From: Oswald, Hank
Sent: Friday, June 22, 2018 9:37 AM
To: 'Lili Mundroff'
Subject: RE: Balcerzak Residence_Proposed Addition_7303 Meadow Wood Way

At this time, we would like confirmation on the size and condition of the existing septic tank. If the tank hasn't been pumped recently, please have the homeowners hire a septic contractor to pump the tank and note the size and condition on the invoice. This information will help us determine next steps toward BP approval.

drawing
proposed floor plans

1" = 40'

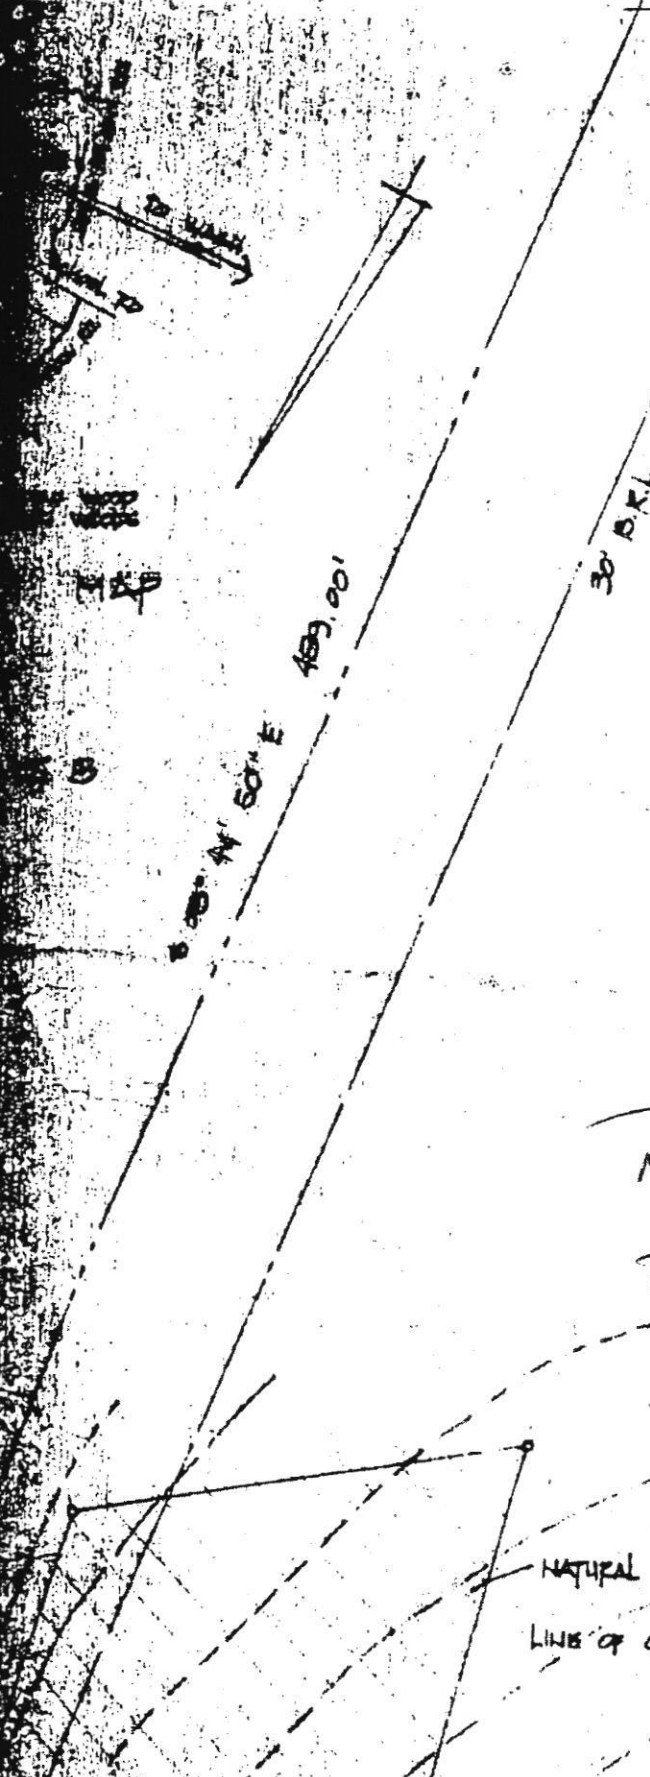
8-29-91 Proposed ad
would place garage
from septic tank. Loc
not in conflict with
well; Septic tank probe
pumped recently, looks
Recommend additional
for Lot 1 bedroom addition
3.018 ACRES R.H.'s note &
re: ok for 1 bedroom incre
not 2 bedrooms, as is
changes to septic system,

NO EVIDENCE TO INDICATE
LIKELIHOOD OF PROBLEM
POTENTIAL RESPAIN CAPACIT.
VIA PLATTED 10,000 SQ.F.

1 existing first floor plan
 scale: 1/4" = 1'-0"

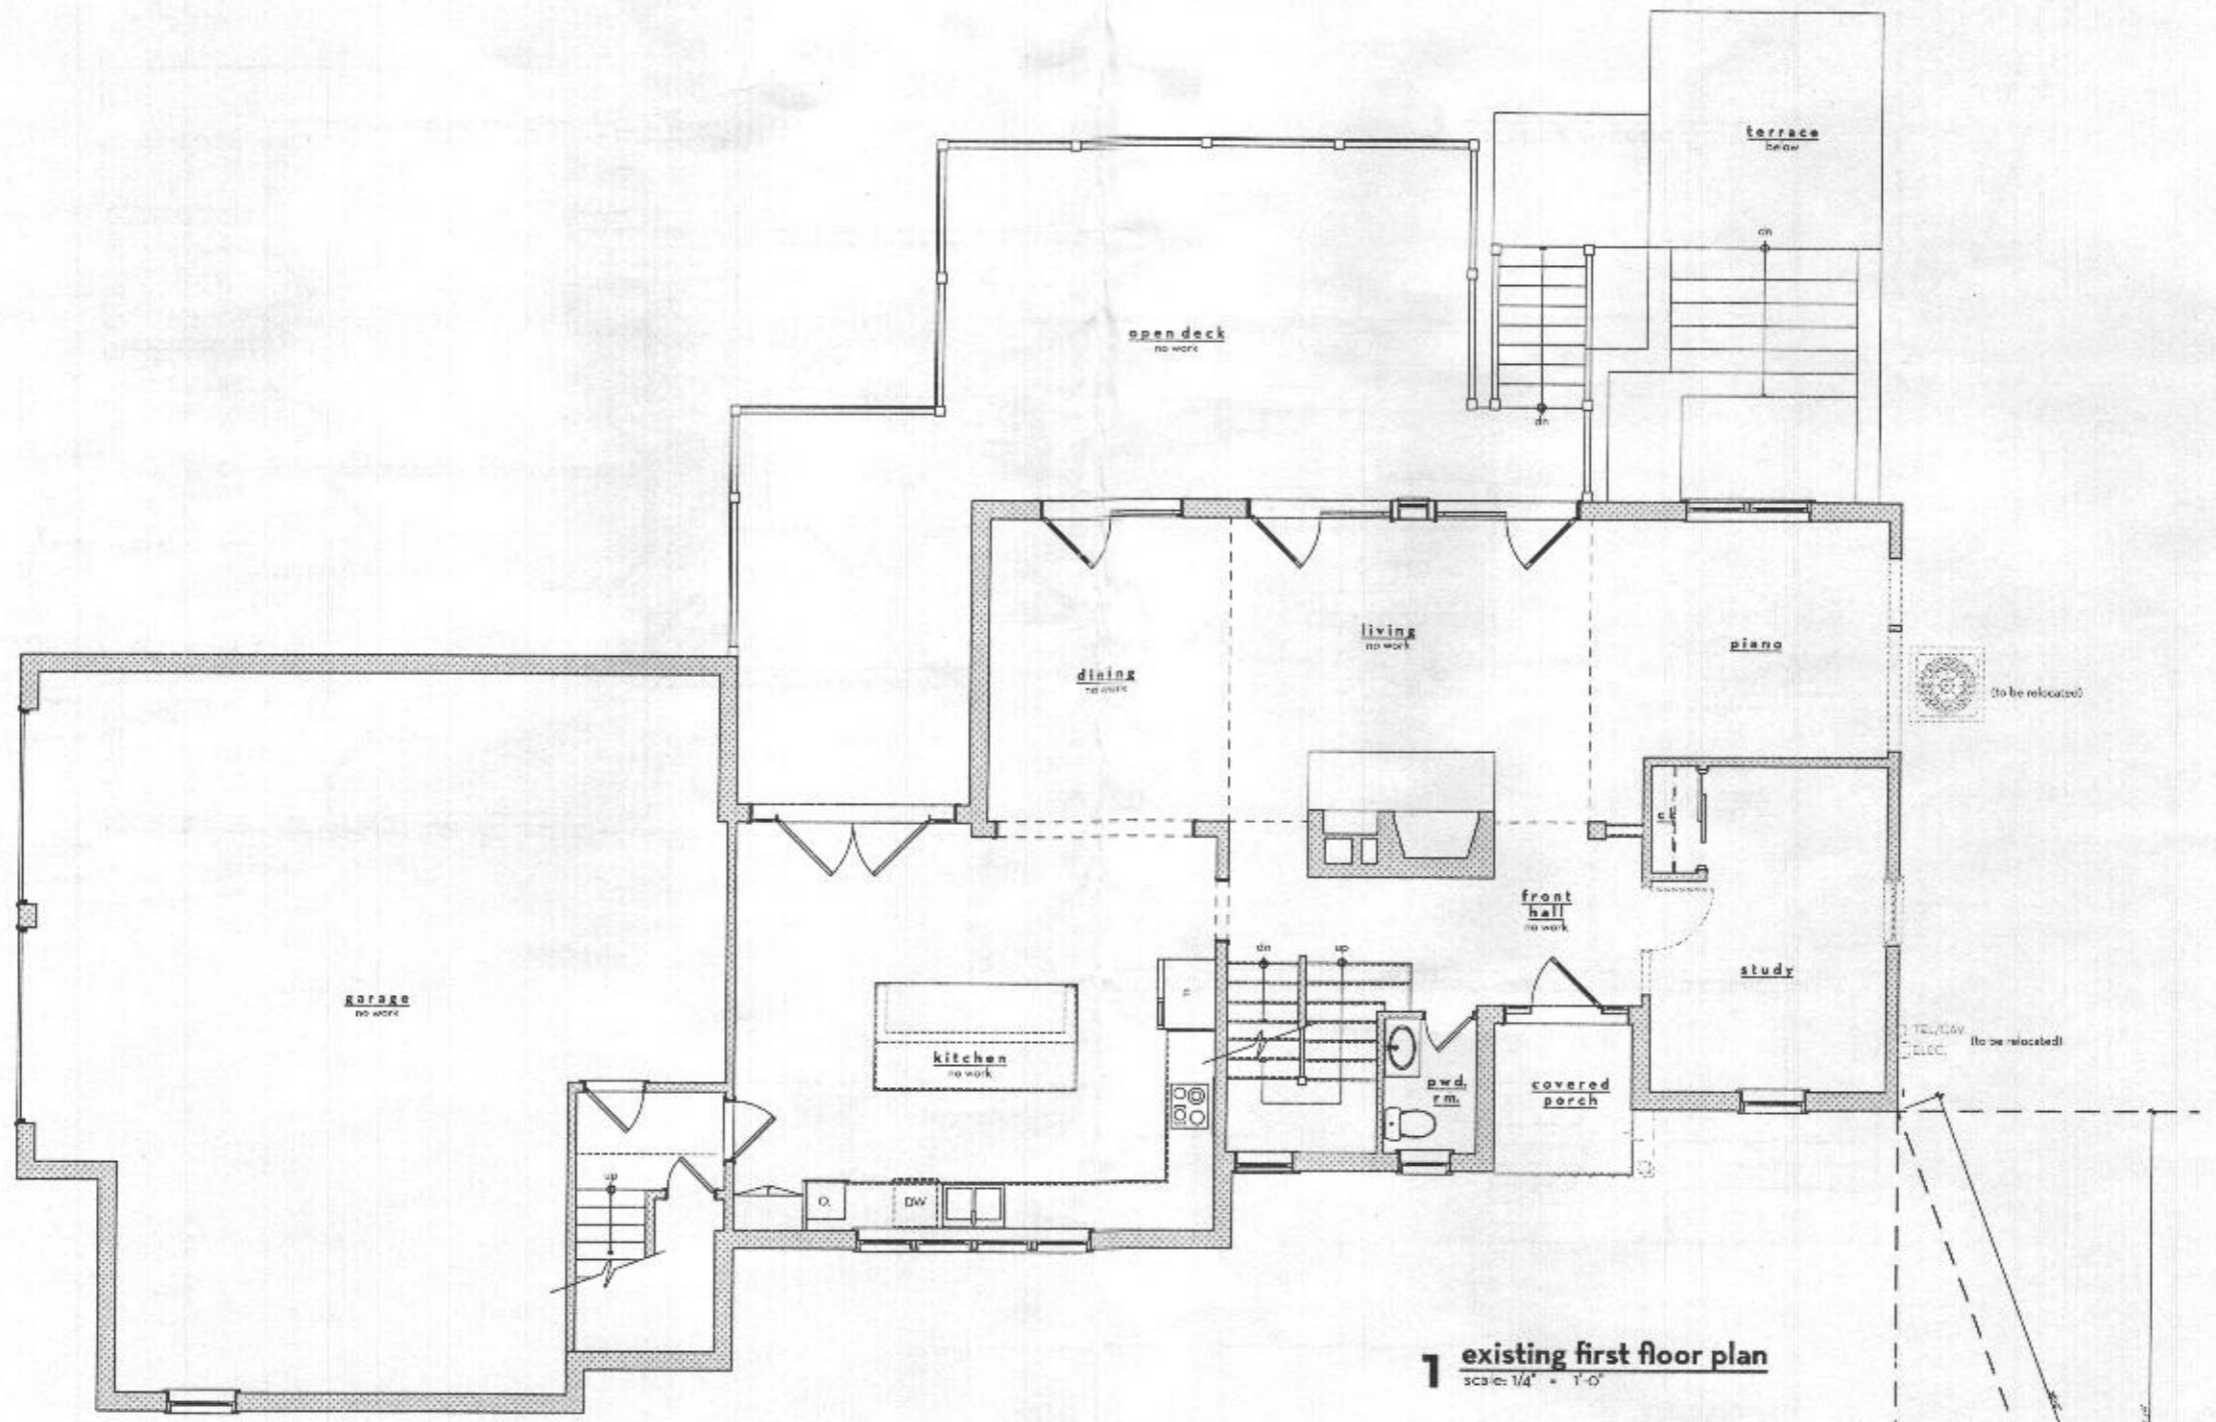
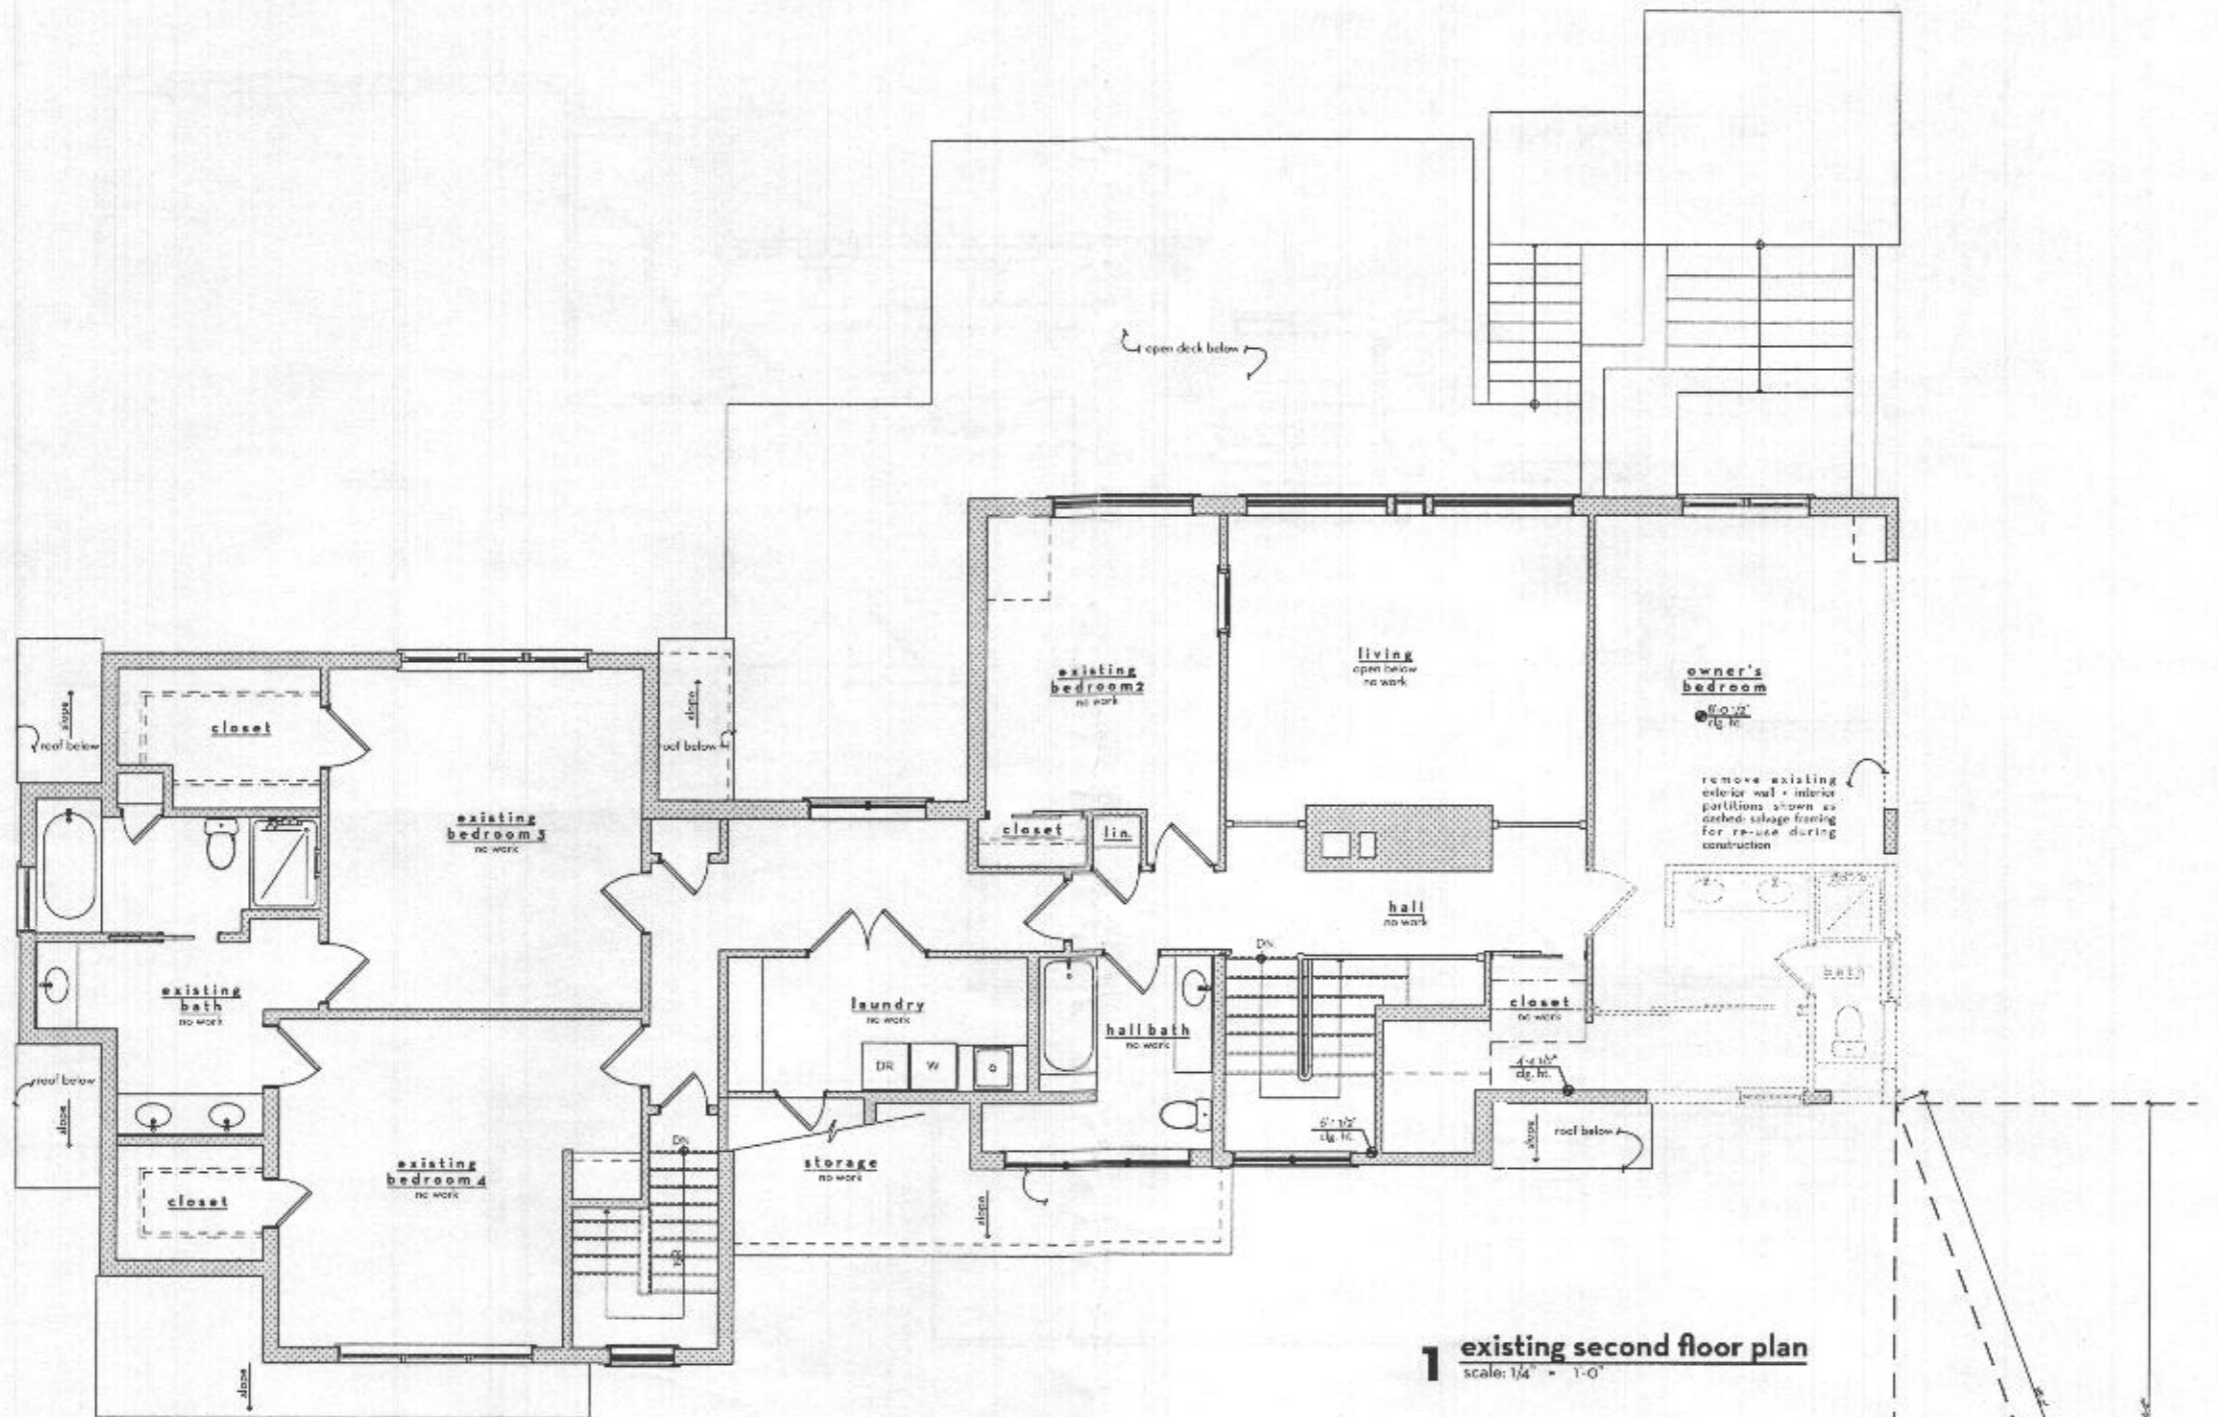
We went back to measure the remaining portion of the house indicating the correct number of bedrooms and baths. There are currently 4 bedrooms and (3) full baths and (1) half bath in the first floor - there is no plumbing connection in the basement (see revised plans).

Our current proposed work is not changing the existing number of bedrooms or baths. The last plans (showing 4 bedrooms and 3 1/2 baths) were submitted on May 15, 2009 and approved thereafter. At that time, the intent was to change from a 3 bedroom to a 4 bedroom house. Based on the septic records that you forwarded, there is a note on August 29, 1991, allowing a future change from 3 bedroom to 4 bedroom (see attached). I am assuming that the earlier septic note allowed the May 2009 plans to be approved. I believe that the current status of the house is in compliance with the septic notes - i.e one additional bedroom (4th) to the existing 3.
